An Ordinary Meeting of Lismore City Council will be held at the Council Chambers on December 9, 2025, 10.00am

10.5 Get NSW Active, Standing Street, Mills Street to The Channon Public School, The Channon

Attachment 1: Attachment A - P25045 Standing Street Footpath Review Rev B_redacted60

Review and Assessment Report

Table 3 - Assessable Options and Descriptions

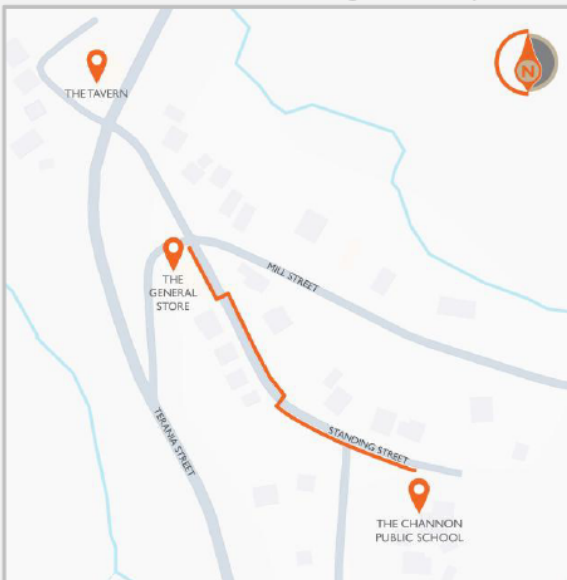
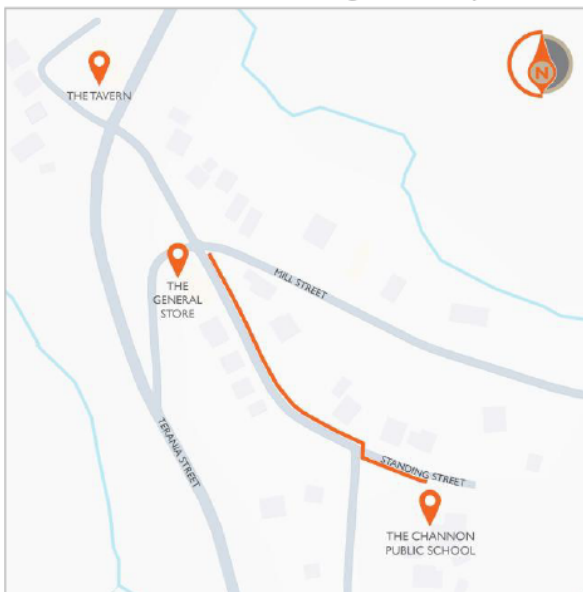
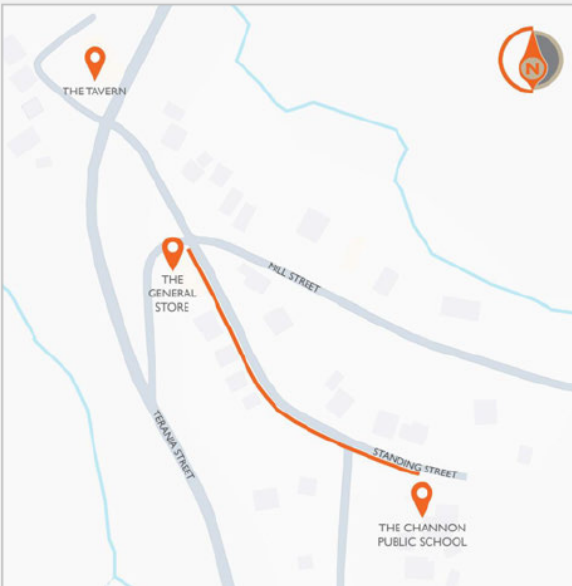
OPTION		DESCRIPTION
A	No change (existing conditions)	Implementing no shared path in The Channon, resulting in the existing conditions remaining, including the installed section of the shared path between the entrance to the school and Nimbin Street.
B	Shared Path Design	<p>The initial design plan proposed by LCC to implement a shared path between the end of the existing shared path (at Nimbin Street) and the General Store (intersection of Standing Street and Mill Street).</p> <p>The total number of road crossings for this option is three (3).</p> 
C	Amended Shared Path Design	<p>Amended design plan proposed by LCC to implement a shared path between the end of the existing shared path (at Nimbin Street) and the General Store (intersection of Standing Street and Mill Street).</p> <p>The total number of road crossings for this option is one (1).</p>

OPTION		DESCRIPTION
D	Alternate Shared Path Proposal	<p>The proposed alternate design option would include a shared path design between the entrance to The Channon Public School and the General Store (intersection of Standing Street and Mill Street), with the omission of the Standing Street road crossings proposed in Options B and C.</p> <p>The total number of road crossings for this option is one (1).</p>

Figure 4 - Recommended Option D

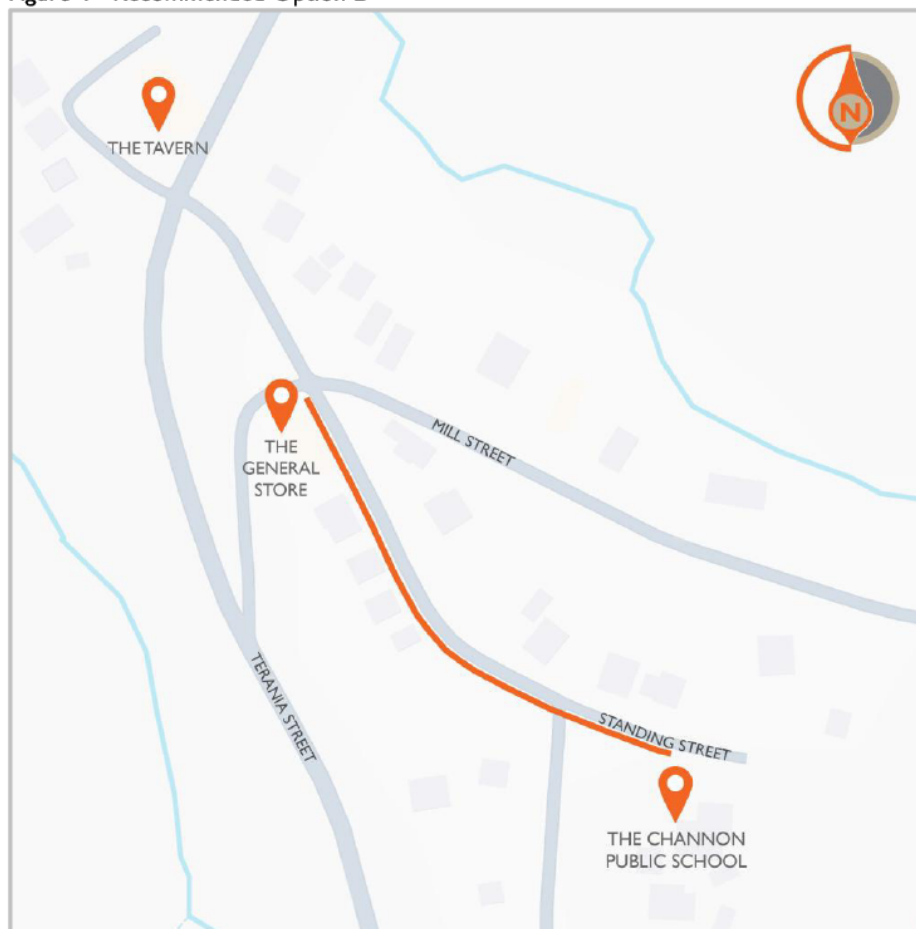
Option D is considered for the shared path alignment between Mill Street and the school. This option has been selected due to its alignment with the key elements, as follows:

- **Functionality** - Provides the most intuitive and direct route to the school and the General Store.
- **Design Guidance** - Will likely be able to achieve the majority of the desired outcomes outlined in the reviewed standards and guidelines.
- **Risk** - Reduces risks associated with existing conditions and introduces the fewest risks of the proposed concept designs.
- **Constructability** - Proposes the least complex alignment for construction, with some minor constructability challenges (when compared to other options).
- **Funding Eligibility** - Best aligns with the Get NSW Active funding initiative.

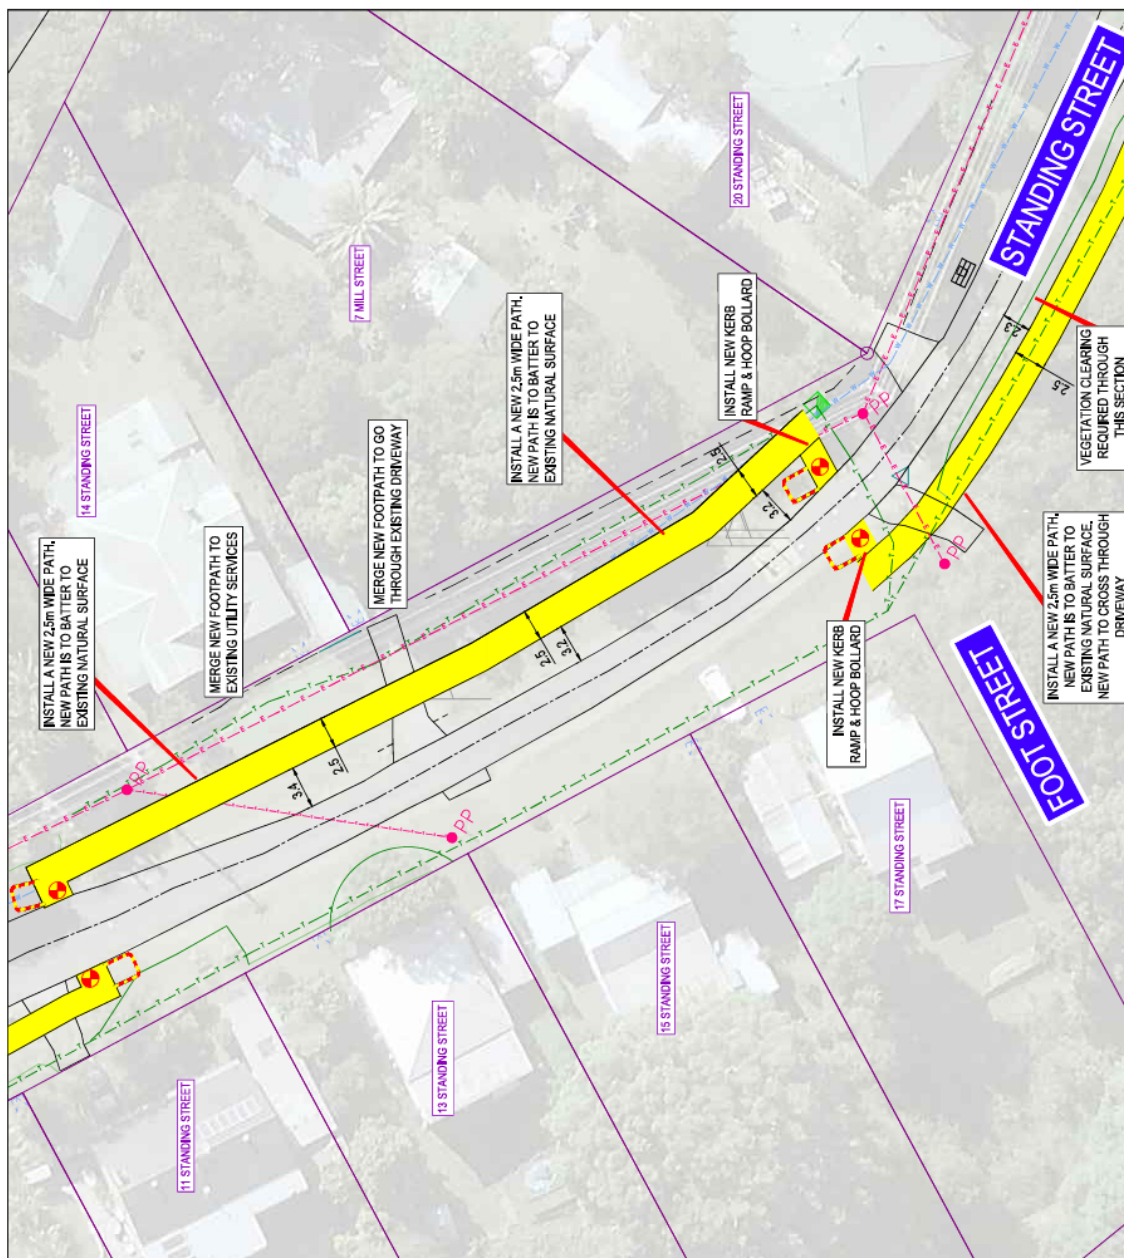
Item	Dwg No.	Description	Response
1	3, 5	<p>Multiple Road Crossing</p> <p>The path is shown to cross Standing Street in two locations. Path users must cross Standing Street, then approx. 70m further along the path, cross Standing Street again. This introduces 2 potential points of conflict into the path route.</p> <p>Path users may be struck by a vehicle while crossing the road. Alternatively, path users may choose to walk on the road or verge rather than cross the road.</p> <p>Frequency: Unlikely Severity: Serious Risk: High</p>	<p>Client acceptance Y/N ____</p> <p>Client response: _____</p> <p>_____</p> <p>_____</p> <p>_____</p> <p>_____</p>
2	3, 5, 7	<p>Hazards Adjacent to Path</p> <p>There are several hazards adjacent to the path:</p> <ul style="list-style-type: none"> - Small tree near the General Store - Trees on western side of Nimbin Street crossing - Several power poles. Some are adjacent to steeper path grades - Steep bank at School. <p>An errant cyclist could impact one of the hazards. Where the path gradient is steeper, the impact could be at speed.</p> <p>Frequency: Rare Severity: Minor Risk: Negligible</p>	<p>Client acceptance Y/N ____</p> <p>Client response: _____</p> <p>_____</p> <p>_____</p> <p>_____</p> <p>_____</p>

3	3, 5	Crossing Driveways <p>The path crosses several driveways. A vehicle entering or leaving a driveway could strike a pedestrian or a cyclist on the path. A reversing vehicle may run over a child which would be obscured from the driver's line of sight.</p> <p>Frequency: Rare Severity: Fatal Risk: High</p>	Client acceptance Y/N ____ Client response: _____ _____ _____ _____ _____
4	3, 5	Vehicles Parked Across Path <p>Vehicles currently park in driveways across the proposed path route. These vehicles would be an obstruction and may also cause line of sight issues for passing traffic.</p> <p>To avoid a parked vehicle, path users may walk or ride on the road, increasing the risk of being struck by a vehicle.</p> <p>Frequency: Rare Severity: Serious Risk: Medium</p>	Client acceptance Y/N ____ Client response: _____ _____ _____ _____ _____
5	7	Steep Path Gradients <p>Steeper path down gradients, especially approaching the Nimbin Street crossing, may cause cyclists to overshoot the end of the path into the travel lane.</p> <p>A cyclist may be struck by a passing vehicle or run into a stopped vehicle.</p> <p>Frequency: Rare Severity: Serious Risk: Medium</p>	Client acceptance Y/N ____ Client response: _____ _____ _____ _____ _____

6	3, 9	End of Path at General Store 1 <p>The path at the General Store has no continuation. There is no signage to indicate that the path ends. Sight distances for path users are restricted.</p> <p>Path users may cross the intersection in an uncontrolled manner and be struck by a vehicle.</p> <p>Frequency: Rare Severity: Serious Risk: Medium</p>	Client acceptance Y/N ____ Client response: _____ _____ _____ _____ _____

7	3	End of Path at General Store 2 <p>A hoop bollard is shown across the end of the path. The path has not been widened at the end to accommodate this device.</p> <p>A cyclist travelling at speed may collide with the hoop bollard across the path.</p> <p>Frequency: Rare Severity: Moderate Risk: Low</p>	Client acceptance Y/N ____ Client response: _____ _____ _____ _____ _____
8	3	Vehicles Parked Adjacent to Path <p>Where vehicles can park adjacent and parallel to the path (particularly near the Store), there is a risk that a passing cyclist may be struck by an opening vehicle door.</p> <p>Frequency: Rare Severity: Moderate Risk: Low</p>	Client acceptance Y/N ____ Client response: _____ _____ _____ _____ _____
9	3	Trip Hazards <p>There is a raised pit lid/inspection opening in the northern most driveway to the Store. Unless modified during construction (which is not noted on the plans) this may present a trip hazard to pedestrians.</p> <p>A pedestrian may trip and fall.</p> <p>Frequency: Rare Severity: Minor Risk: Negligible</p>	Client acceptance Y/N ____ Client response: _____ _____ _____ _____ _____

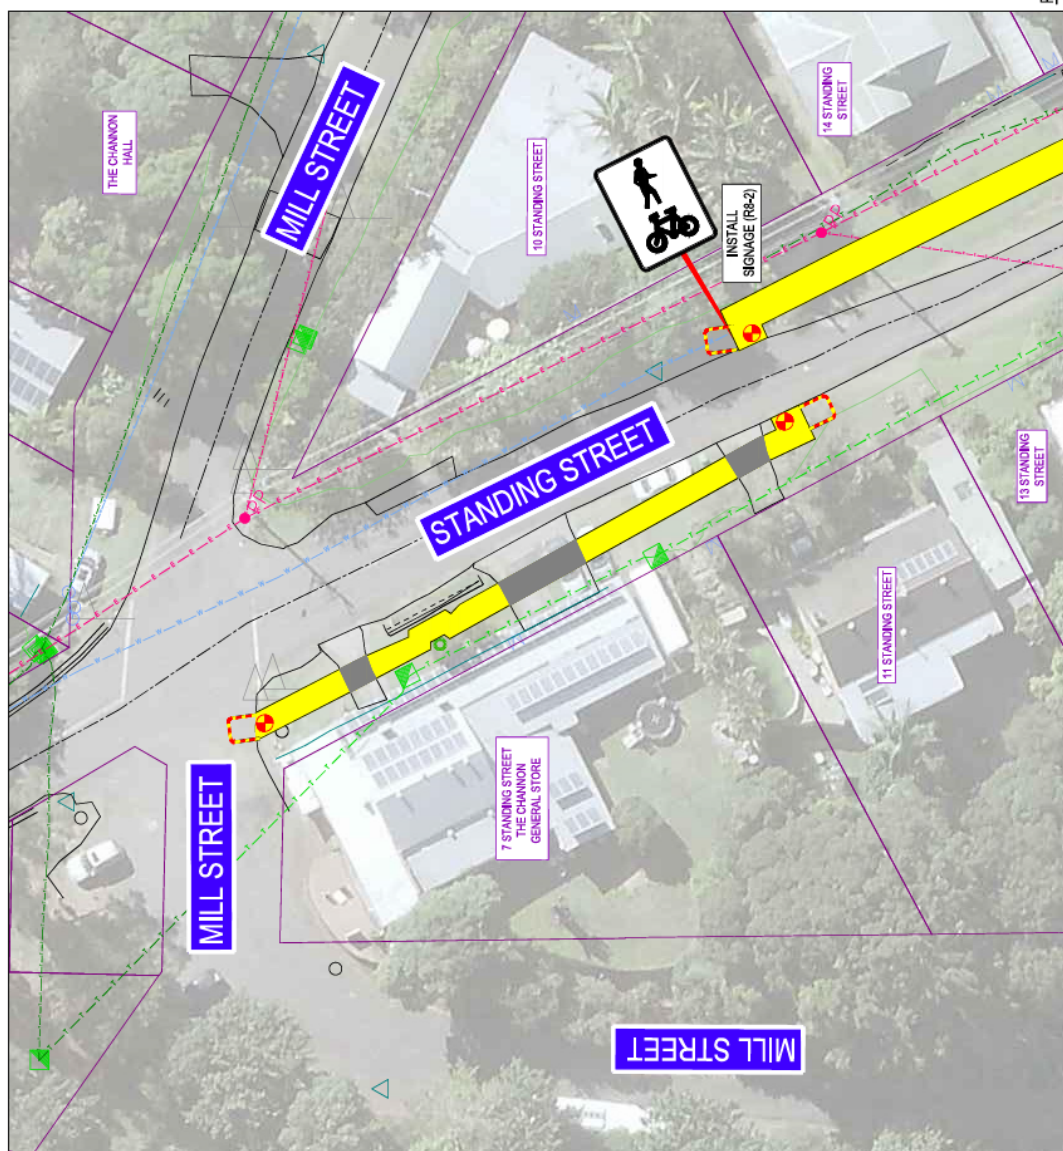
10	3, 5, 7	Roadside Drainage – Water Flowing Across Path <p>Where the paths cross the road, there does not appear to be any provision for roadside drainage. Water flowing in roadside drains/swales may flow across the path.</p> <p>To avoid the flowing water, path users may walk or ride on the road, increasing the risk of being struck by a vehicle.</p> <p>Frequency: Rare Severity: Serious Risk: Medium</p>	Client acceptance Y/N ____ Client response: _____ _____ _____ _____ _____

11	5, 7	Road Width Where Paths Cross Road <p>Where the paths are shown crossing Standing Street and Nimbin Street, hoop bollards are provided. The width between these hoop bollards is too narrow for two cars to pass.</p> <p>Cars needing to pass may collide with the hoop bollards or a path user waiting to cross the road. Or a car may stop suddenly due to the narrowed road and a rear-end crash may occur.</p> <p>Frequency: Rare Severity: Serious Risk: Medium</p>	Client acceptance Y/N ____ Client response: _____ _____ _____ _____ _____
12	5	Angle of Crossing near #17 Standing Street <p>The crossing location shown near #17 Standing Street is shown as acute (not square to the road). Path users may not use the crossing location, increasing the risk of being struck by a vehicle.</p> <p>Frequency: Rare Severity: Serious Risk: Medium</p>	Client acceptance Y/N ____ Client response: _____ _____ _____ _____ _____
